[Docket No. 2002-SW-25-AD; Amendment 39-13217; AD 2003-13-15]

Airworthiness Directives; Schweizer Aircraft Corporation Model 269A, 269A-1, 269B, 269C, and TH-55A Helicopters

ACTION: Final rule.

Figure 1

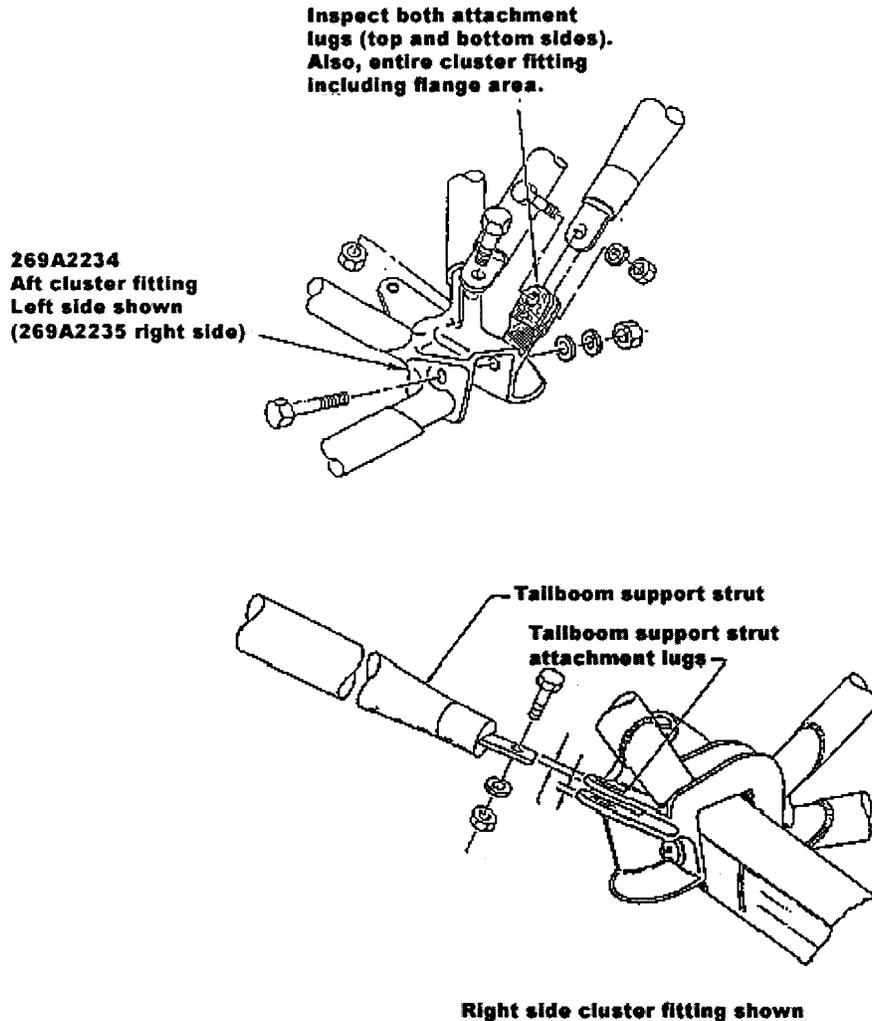
(2) Dye-penetrant inspect the lugs on each cluster fitting. See the following Figure 1:

(3) If a crack is found, before further flight, replace the cracked cluster fitting with an airworthy cluster fitting.
